**MANDATORY****MTB-44-01****TITLE**

CABIN SYSTEMS - AVANCE L3 SYSTEM WIRING MODIFICATION TO PREVENT TCAS FAIL MESSAGE

Super King Air B300

This service document provides parts and instructions to add a diode to the wiring for the L3 Avance system.

Figure 1. Diode Installation (Sheet 1)

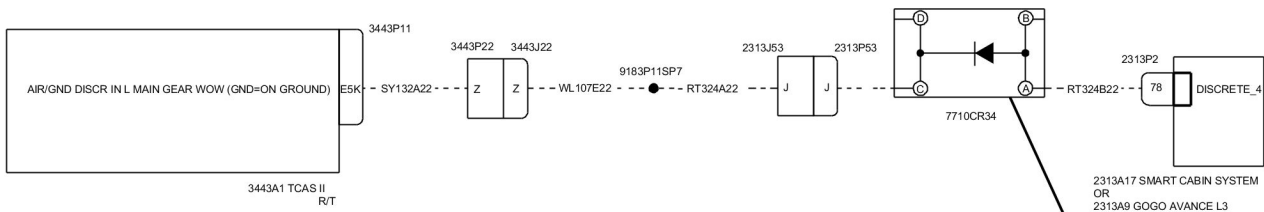
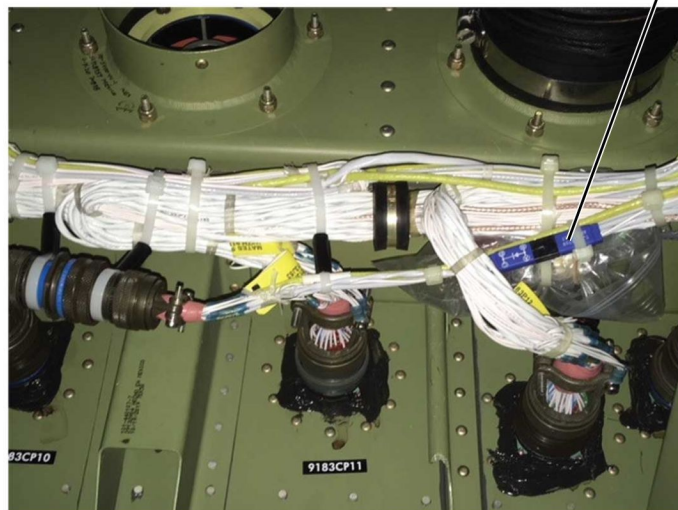
3. Do the wiring modification.
  - A. (Refer to Figure 1.) Cut the RT324B22 Wire.
  - B. Install the TJSE20709 Diode on the RT324B22 Wire. (Refer to the King Air Standard Practice Chapter 20 – Airframe, Electrical Wiring – Maintenance Practices).

Before Modification

After Modification

TJSE20703 Diode (1 Required)
